VALIDATION OF THE CAIXA ECONÔMICA FEDERAL SOLID WASTE MANAGEMENT AND CARBON FINANCE PROJECT

REPORT No. **BRAZIL**-VAL/03745/2010-SPL
REVISION No.2

VALIDATION REPORT

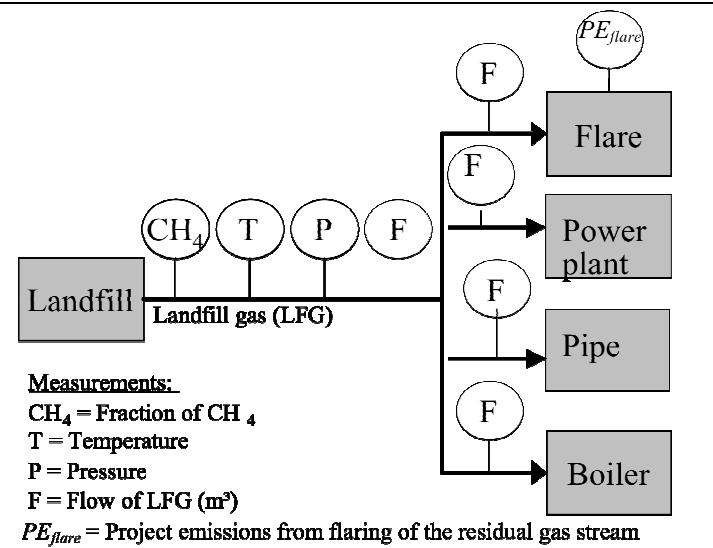
h. Had the selected methodology been correctly applied with respect to monitoring methodology?	VVM	67			
i. Is the monitoring methodology based on direct measurement of the amount of landfill gas captured and destroyed at the flare platform(s), the natural gas pipelines and the electricity generating/thermal energy unit(s) to determine the quantities as shown in Figure 1 of the methodology ?	ACM	0001	Yes, the measurement of the amount of landfill gas captured is monitored at each of the platforms based on direct measurement according to the figure 01.	OK	OK
